UNITED STATES PATENT AND TRADEMARK OFFICE

APPLICATION NO.	FILING DATE	FIRST NAMED INVENTOR	ATTORNEY DOCKET NO.	CONFIRMATION NO.
10/705,899	11/13/2003	Joun Ho Lee	8733.275.20-US	6109
30827	7590	10/23/2006	EXAMINER	
MCKENNA LONG & ALDRIDGE LLP 1900 K STREET, NW WASHINGTON, DC 20006			NGUYEN, HOAN C	
			ART UNIT	PAPER NUMBER
			2871

Office Action Summary

FIG. 4

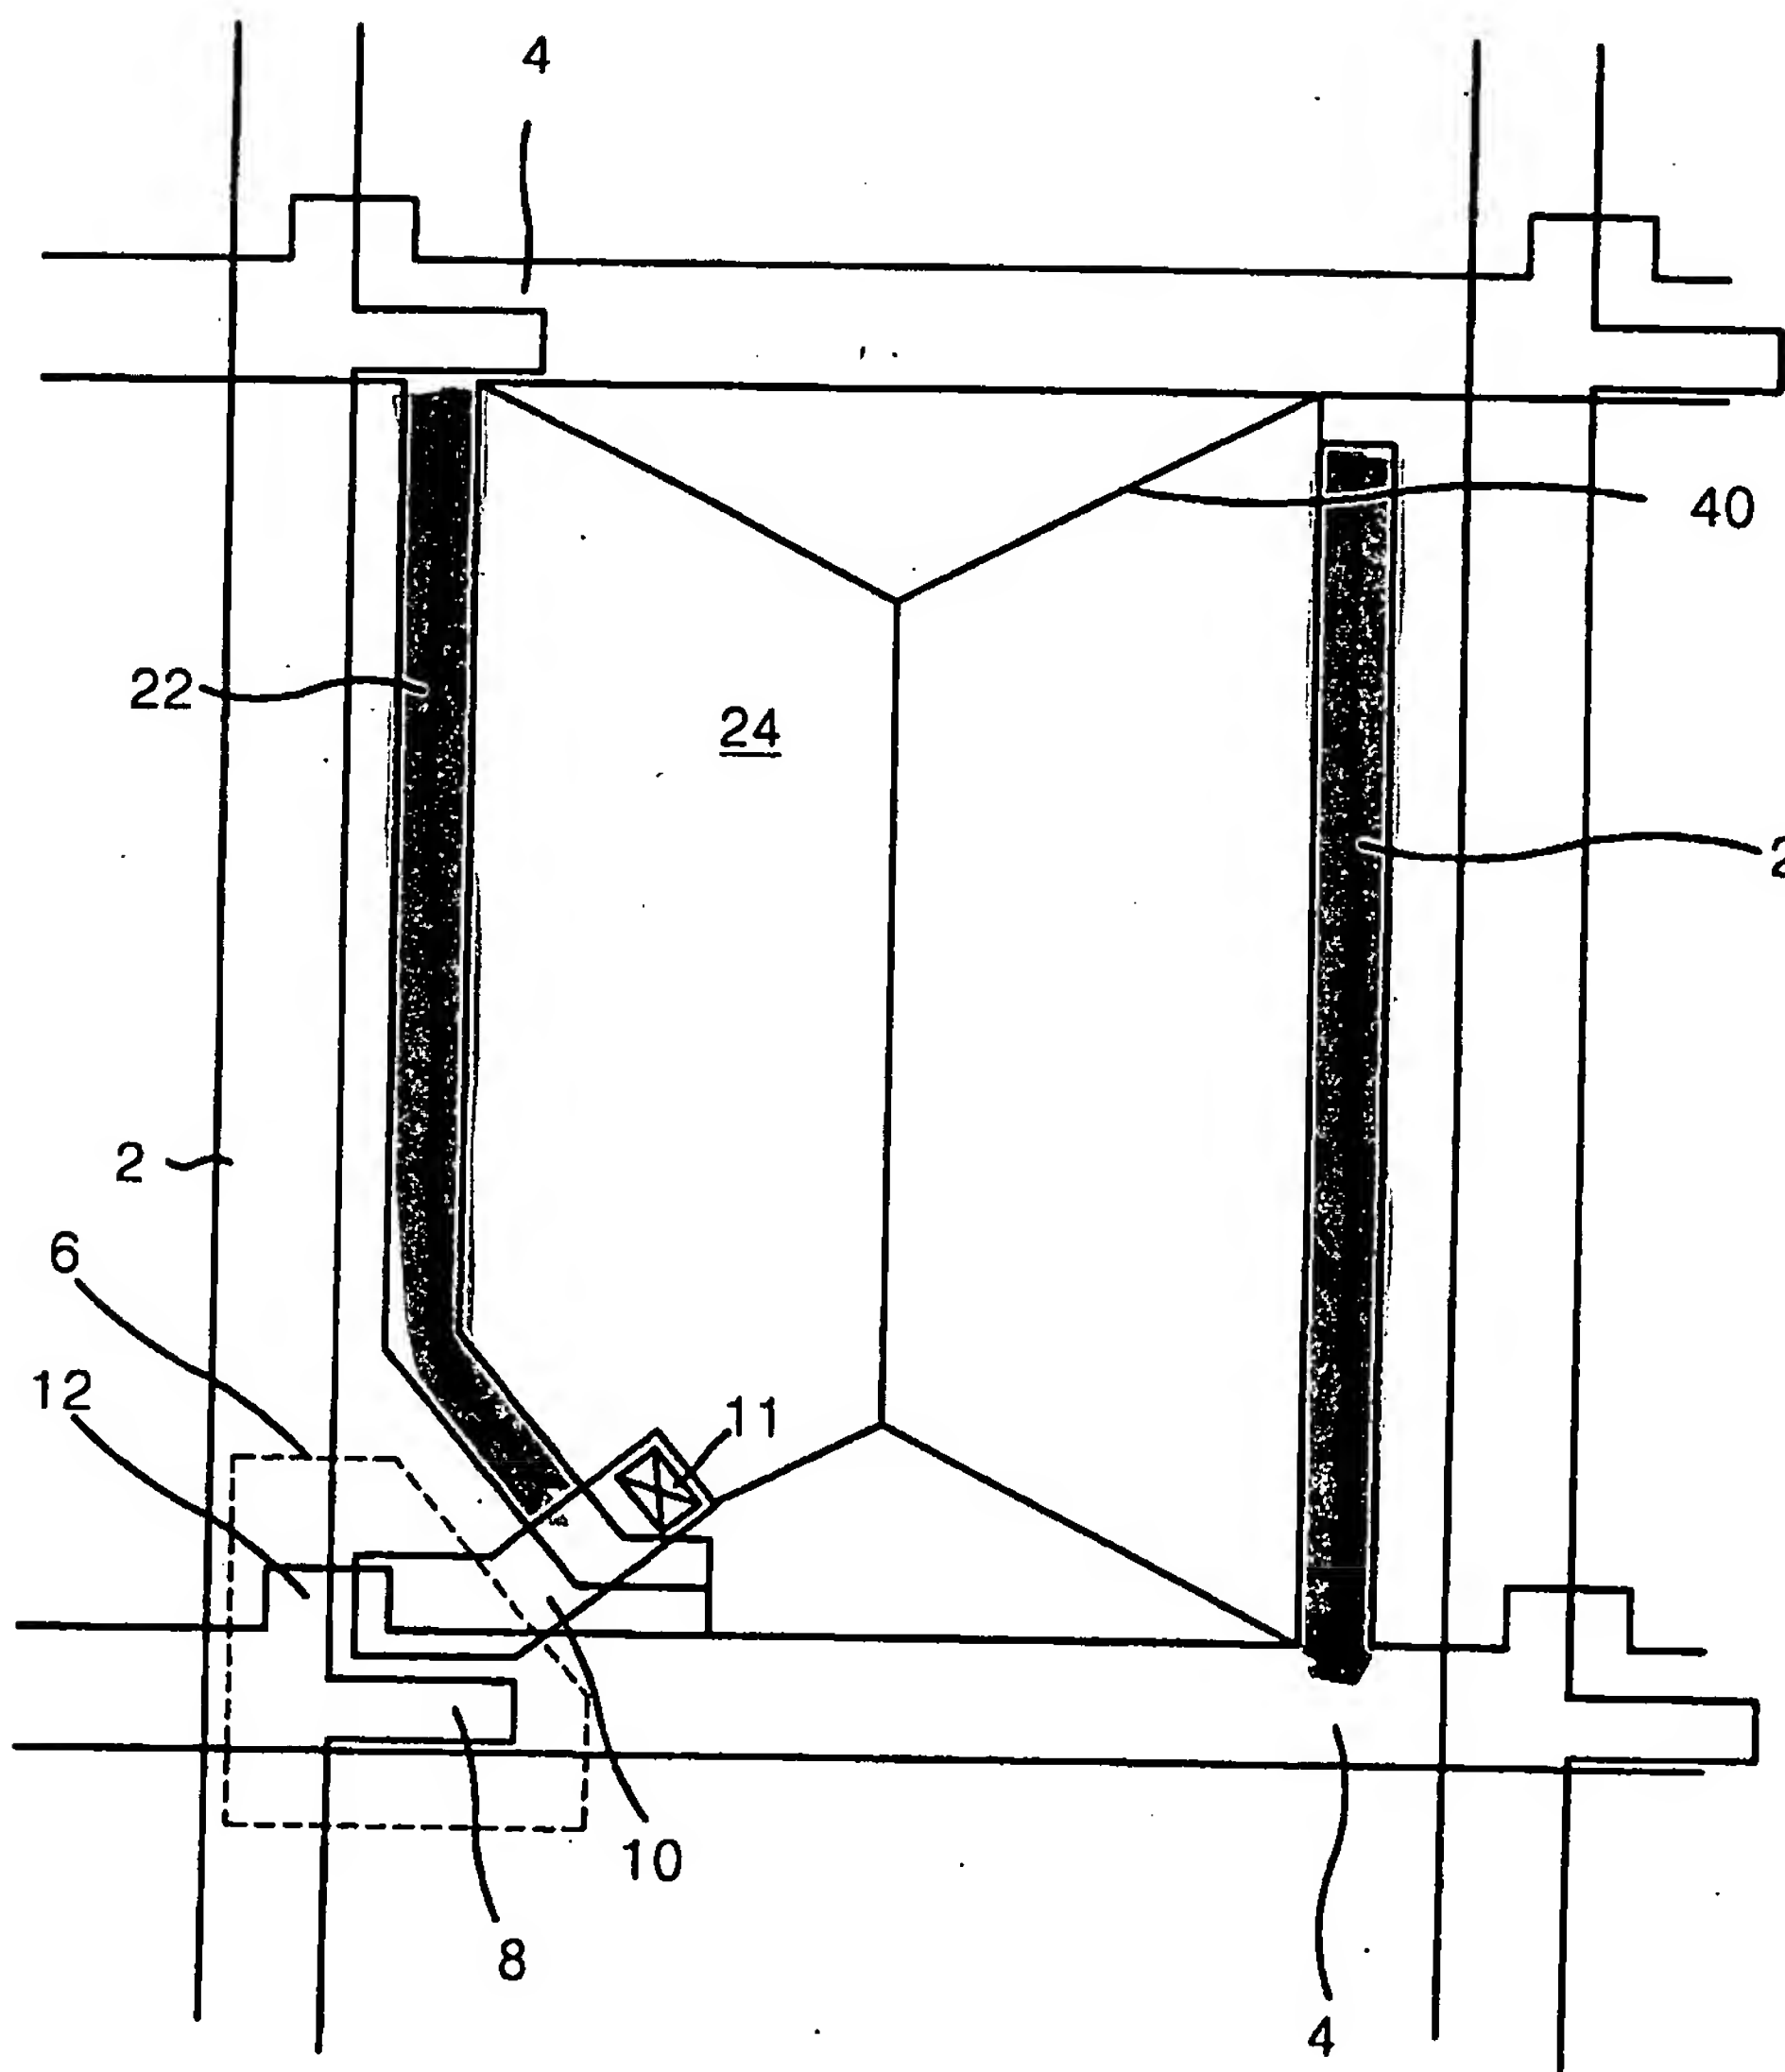
Fig. 4 shows that the auxiliary electrode line (extending from and connecting with gate lines) is formed between the pixel electrode and the data line at an outside of the pixel electrode in the pixel region and the auxiliary electrode 22 is not overlapped with the pixel electrode 24, but also not overlapped with the data line (see attachment).

Therefore, the combination of the features

- (a) the auxiliary electrode line is electrically connected to gate line.
- (b) the auxiliary electrode is overlapped with the pixel electrode,
- (c) the auxiliary electrode is not overlapped with the data line

is not disclosed in the original disclosure. This combination arises the new subject matter.

auxiliary
electrode is
not overlapped
with pin
electrode 2x
